Informal document **GRE-90-30**  
90<sup>th</sup> GRE, 29 April-3 May 2024  
agenda item 6.(a)

Questions regarding the interpretation of UN R48-08

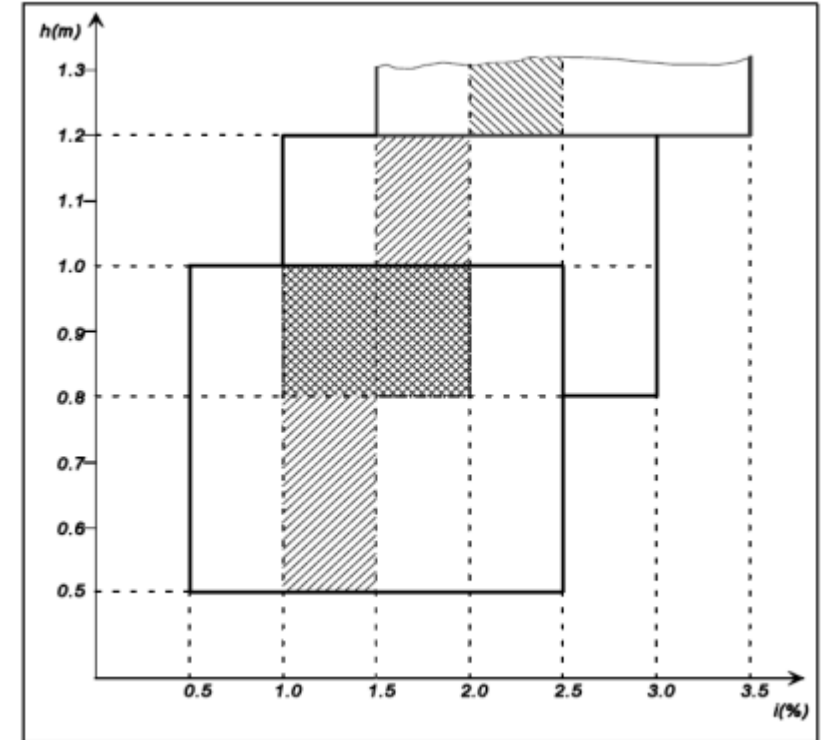
There is no requirement for  $h=0.8$  and  $h=1.0$ .

It is recommended to add:

$$0.8 \leq h \leq 1.0$$
